Timing parameters for Energy Efficient Ethernet Backplane

Adam Healey
IEEE P802.3az Task Force Meeting
Geneva, Switzerland
May 2010

Comment #124: T_{WR} for 10GBASE-KR

Figure 49–16—LPI Transmit state diagram

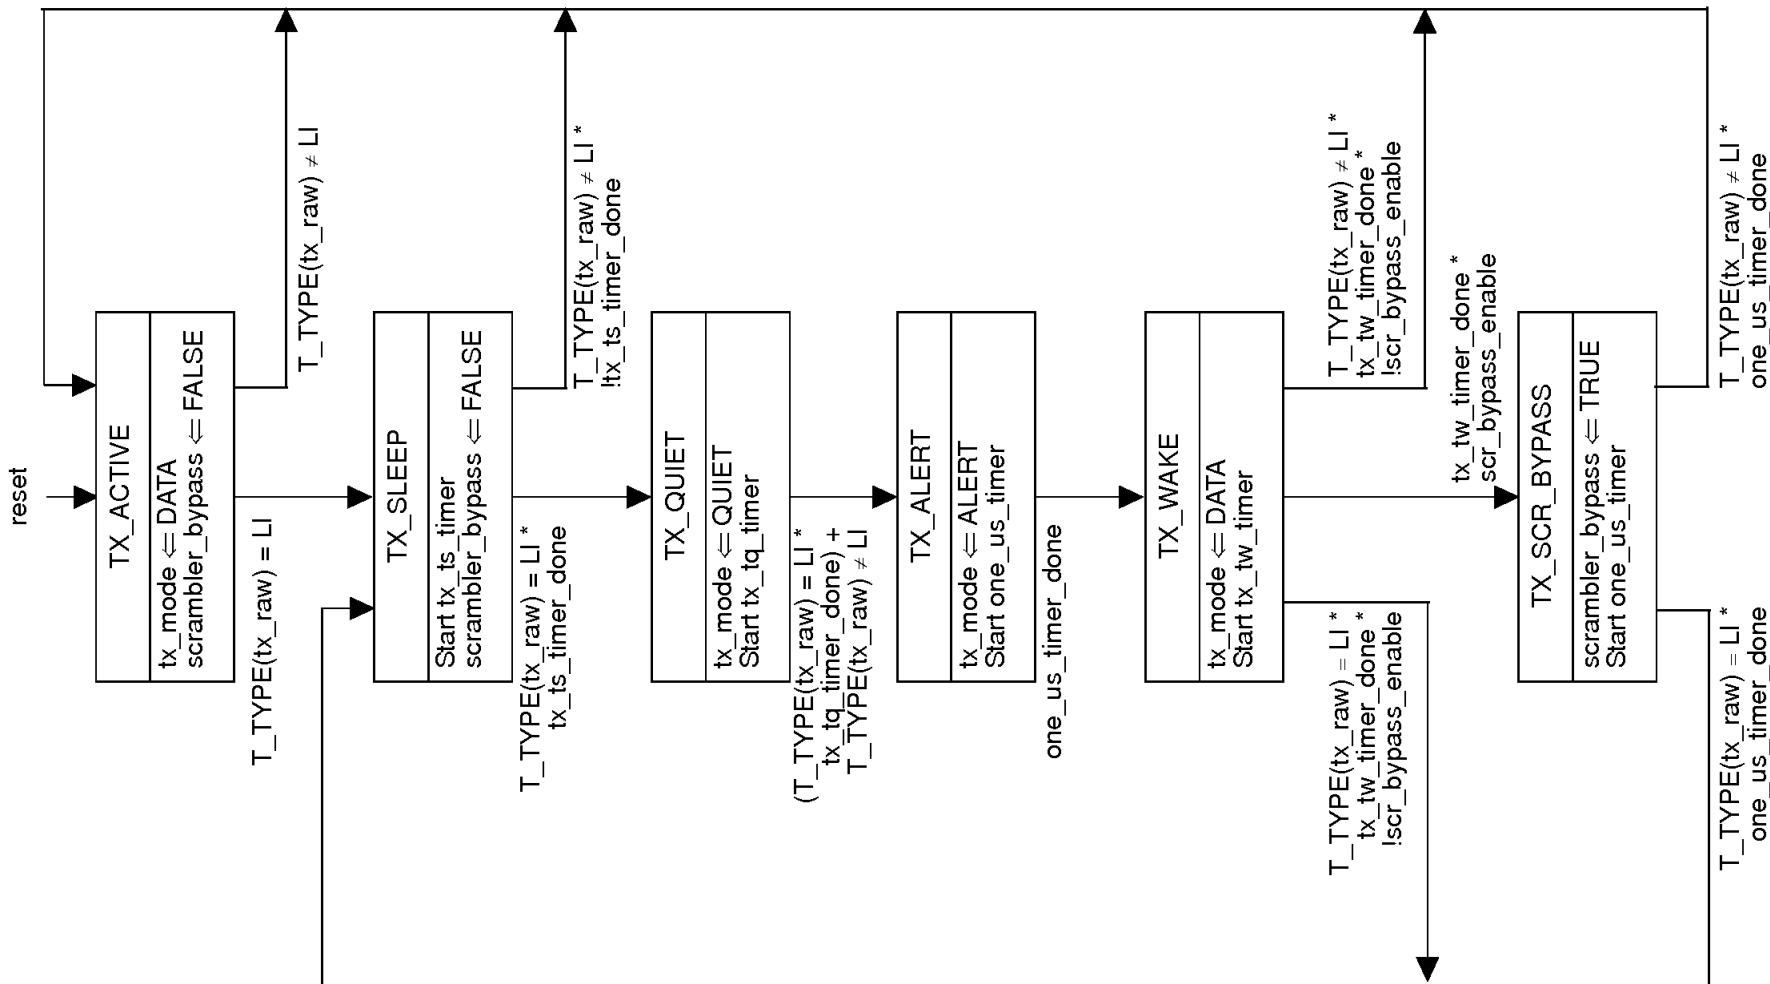
- The values for T_{WR} in Table 49–3 are too large
 - They significantly exceed the minimum permissible value of $T_{w_sys_tx}$ per Table 78–4
 - Packet(s) transmitted immediately following the minimum deferral time, but before `rx_tw_timer_done`, will be lost and no wake error will be recorded to account for their absence
- The rationale for the current T_{WR} values may be found in comment #130 submitted against Draft 2.1
 - If the PHY wakes while in the TX_REFRESH state, scrambler bypass will be delayed
 - The receiver requires scrambler bypass to obtain block lock when the FEC sublayer is used
 - However, there was no need to increase T_{WR} when the FEC sublayer is not used

- Modify the LPI transmit state diagram
 - Define refresh to be TX_ALERT and TX_WAKE immediately followed by TX_SLEEP
 - If scr_bypass_enable = TRUE, unconditionally enter TX_SCR_BYPASS when rx_tw_timer_done
 - From TX_SCR_BYPASS, move to TX_SLEEP (refresh) or TX_ACTIVE (wake) when one_us_timer_done
- Greatly simplifies state diagram structure
- PHY power-up sequence is identical for refresh, wake, and wake from refresh
- T_{WR} can be set to a value that accurately accounts for wake errors
